ALERT SERVICE BULLETIN
Bell Helicopter **TEXTRON**

NO. 407-05-68

SUBJECT: ROLLS-ROYCE 250-C47B ENGINE GEARBOX ASSEMBLY – INSPECTION AND REWORK OF GEARBOX HOUSING.

ENGINE, GEARBOX ASSEMBLY - INSPECTION AND REWORK OF GEARBOX HOUSINGS

Gearbox Housing Borescope Access
FIG. 1

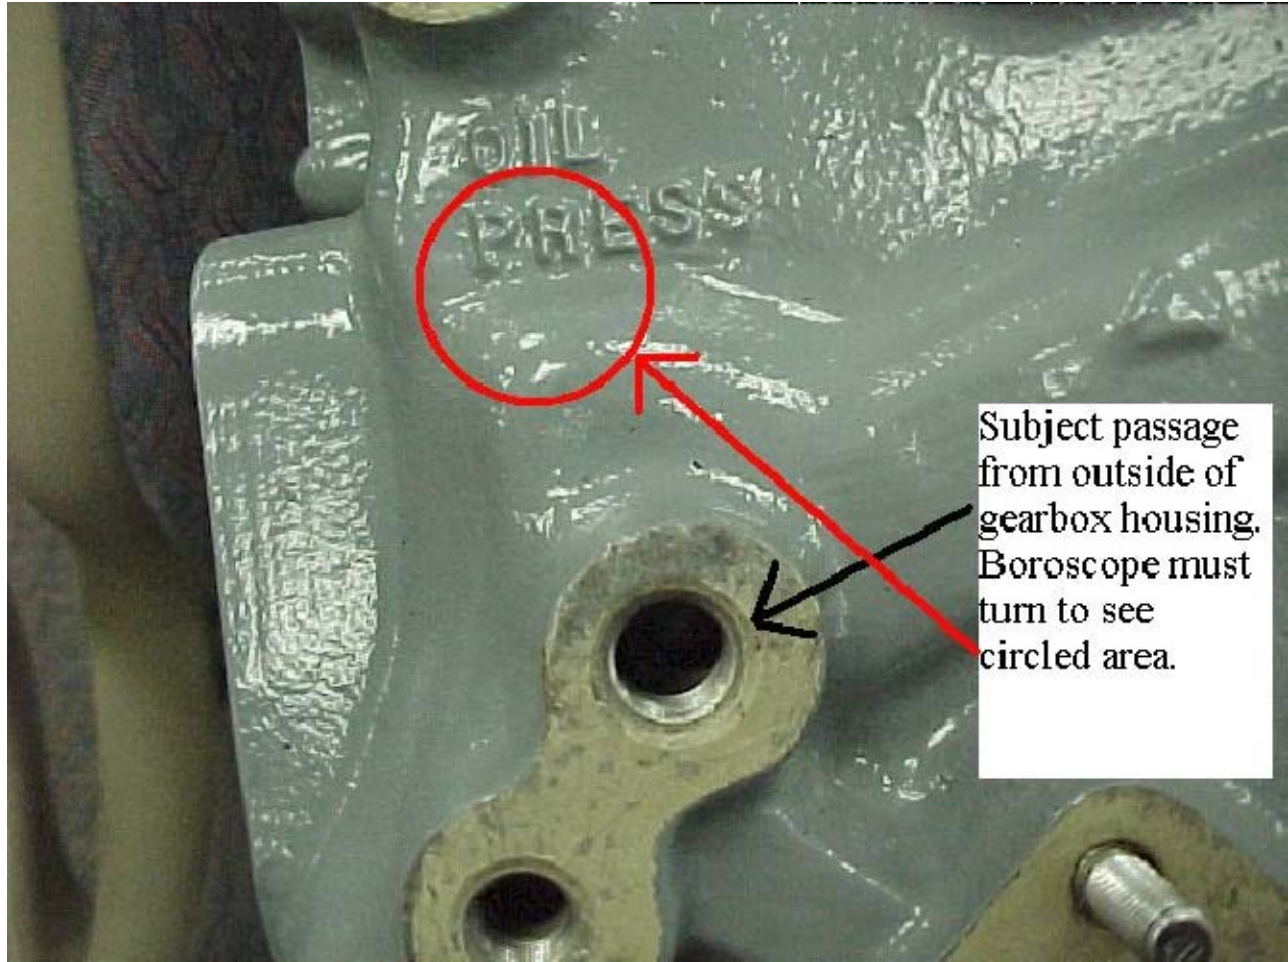
- (a) The borescope is to be inserted into the gearbox housing at the A/C oil pressure gage port, marked PRESS, on the right hand side of the engine. The borescope should then be moved up and to the left (gearbox forward looking aft) (REF. Fig. 1).

- (b) With the borescope positioned in the #6, #7 and #8 bearing oil supply passage, the drill hole should be visible in the aft region of the oil passage.

- (c) Determine if the drill hole is not completely drilled through and free of any machining debris or burrs.
 - If the drill hole is not completely drilled through, or if any debris is noted around the drill hole, then the engine should be removed and sent to a FIRST Network Facility for repair. The FIRST Network Facility is to follow the instructions in 2.C.

- If the oil supply hole is completely drilled through the housing and properly deburred then the proceed to 2.B.
